May 21, 2020

This letter is to announce that NPK will start manufacturing our air tools without paint in 2020.

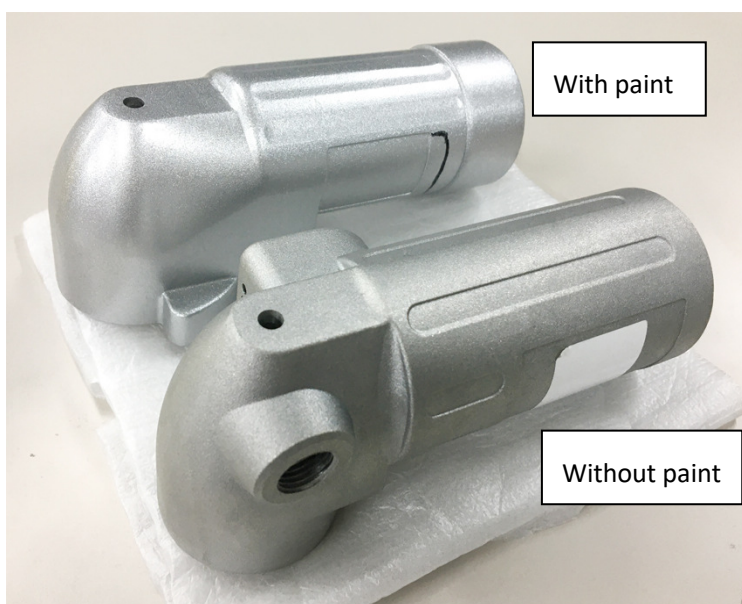
The aluminum casting parts will be shot blast finish with Alodine treatment.

The steel parts will be black-oxidized.

Cationic coating will apply to the guards for anti-corrosion.

To differentiate the tools without paint from the previous tools, we will alter the serial numbers.

Previous tools: SN 01234567 starting from 1

New tools: SN 02000000 starting from 2
